Re: Administrative Order WFX-850

Jalmat Field Yates Sand Unit (JFYSU) Well No. 249 (API No: 30-025-38922)
2030 FSL, 330 FEL, Sec 11, T22S, R35E, NMPM, Lea County

Re: Request to Alter Injection Pattern
Jalmat Field Yates Sand Unit No. 249
API No. 30-025-38922
2030' FSL & 330' FEL (Unit I) Section 11, T-22 South, R-35 East, NMPM,
Lea County, New Mexico

Melrose Operating Company
Jalpat Field Yates Sand Unit No. 249
API No. 30-025-38922
2030' FSL & 330' FEL (Unit I)
Section 11, T-22 South, R-35 East, NMPM
Lea County, New Mexico

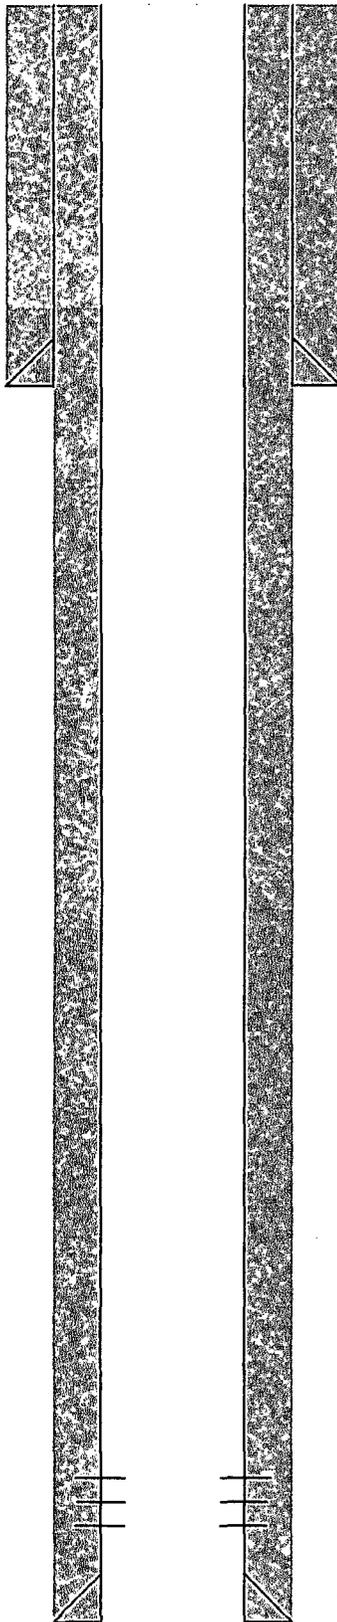
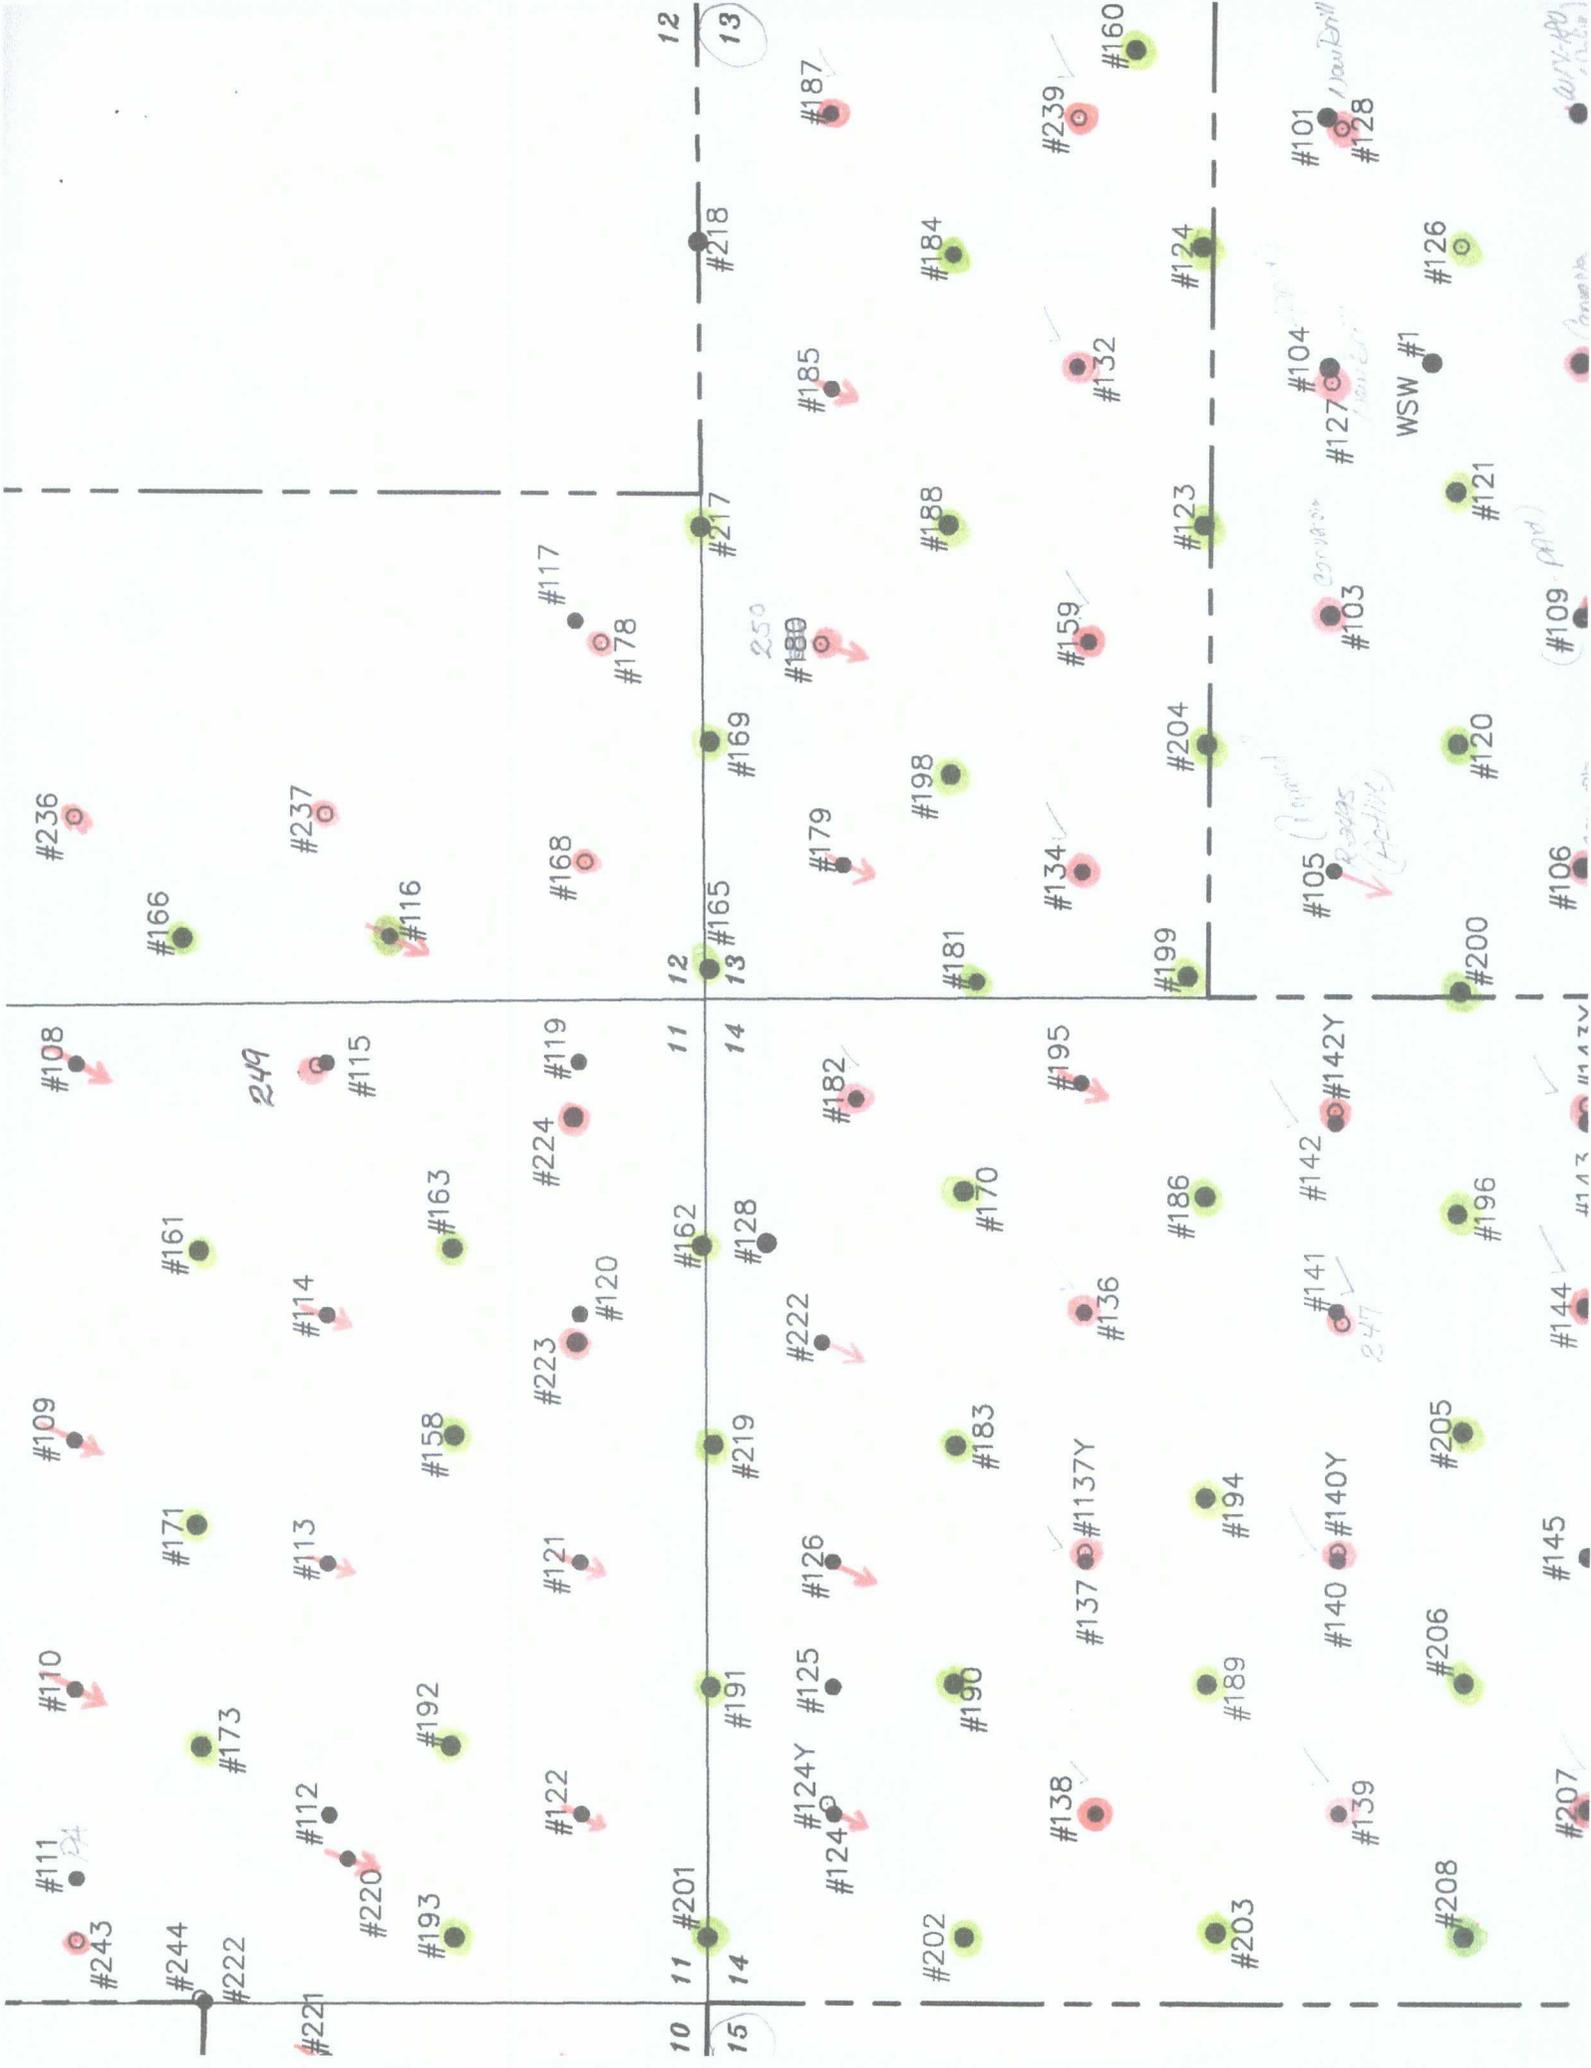
- (a) to change the injection pattern within the JFYSU Waterflood Project, thereby allowing Melrose to utilize the JFYSU No. 249 as a producing well instead of an injection well;
- (b) to plug the JFYSU No. 115 from a depth of 2,261 to the surface in accordance with a plugging program approved by the OCD Hobbs District Office; and
- (c) to continue injection operations in the immediate area of the JFYSU No. 115.

I am enclosing a wellbore diagram of the JFYSU No. 249, and a waterflood pattern map. Plugging operations on the JFYSU No. 115 will commence after the Division has approved Melrose's request to alter the injection pattern within the Jalmat Field Yates Sand Unit Waterflood Project.

The Division hereby grants Melrose's request with the added stipulation that all injection wells within ½ mile of this location remain inactive during time periods when the JFYSU Well No. 249 is not under active artificial lift. The Division's intention is for Melrose to inject in surrounding wells only during time periods when an active pressure sink exists at this location.
